# UNITED STATES PATENT AND TRADEMARK OFFICE

10/821,737

<b>Office Action Summary</b>	<b>Application No.</b> 10/821,737	<b>Applicant(s)</b> SCHWEINBENZ ET AL.	
	<b>Examiner</b> ZACHARY M. PAPE	<b>Art Unit</b> 2835

## **DETAILED ACTION**

**Fig 1**

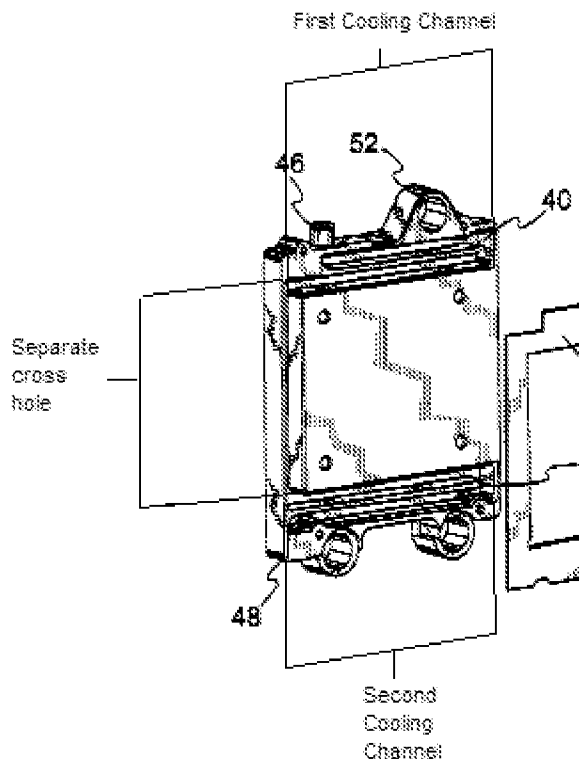
With respect to claim 9, Clamp et al. further teaches that the cooling device includes a plurality of one-piece cooling tubes integrally formed in the bottom section (See Present Office Action Fig 1 below where the first cooling channel, and the second cooling channel, form a plurality of one-piece cooling ducts).

With respect to claim 10, Clamp et al. further illustrates that the one-piece cooling tubes are connected by at least one separate cross hole (Running along the left side of the bottom as illustrated in Fig 2 and present office action Fig 1 below).
